ENGINEERING CHANGE ORDER

BOARD NAME <u>TORRENT CCD AFE BOARD</u>	ECO# TRNT-007	DATE <u>1/4/2010</u>
BRD SERL# <u>006 ></u>	ART# _____	
PN# _____ REV _____	REV _____	
ASBLY# <u>TRNT-EL-04-0004</u> REV <u>OD</u>	PCB# <u>TRNT-EL-04-1004</u>	REV <u>OD</u>
BOM# _____ REV _____	SCH# <u>TRNT-EL-04-2004</u>	REV <u>OD</u>
COGNIZANT ENGNR _____	APPROVD _____

REASON FOR MODIFICATION:
Get board functioning

Figure 1
Item 22 on action list

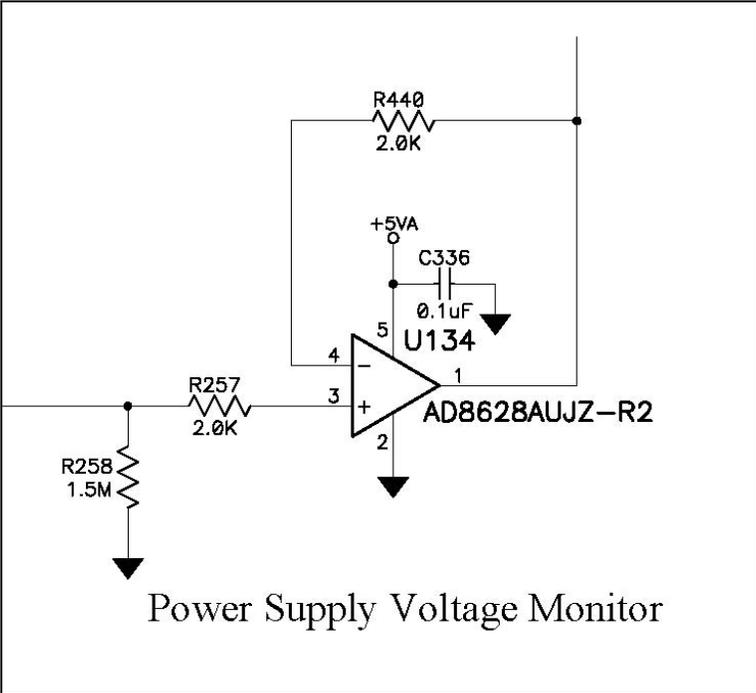
18	pcm 09/22/09	The disable (pin 7) of the ADA4941 devices (U75, U84, U93, U103) should be tied to -5V instead of GND.	
20	dgs 10/5/09	AFE_DATA_EN needs to be /AFE_DATA_EN	
21	pcm 10/07/09 TRNT meeting	U140 24AA128 eeprom Pin 7 (WP) should be tied to ground	
22	dgs 10/8/09	U145 should be wired as a voltage follower (copy of U134), i.e. gain=1, to preserve the 0-5V telemetry voltage range from the MUX to the ADC.	(use graphic on eco) see figure 1
23	dgs 10/30/09	/TELADC0_DOUT CHANGE TO TELADC0_DOUT	
24	dgs 11/2/09	The clock state switches (e.g. U28 for clock 0) are shown in the logic "1" state. Thus, the clock low state is wired to the logic high input. Should this be rewired for all clock channels? Currently this is corrected in firmware. Additionally logic state 0 should be VCLKLO signal, requires signals on pins 6 & 4 to be swapped.	change sch symbol to be drawn in the logic 0 state, additionally logic state 0 should be VCLKLO signal, requires signals on pins 6 & 4 to be swapped & rerouted.
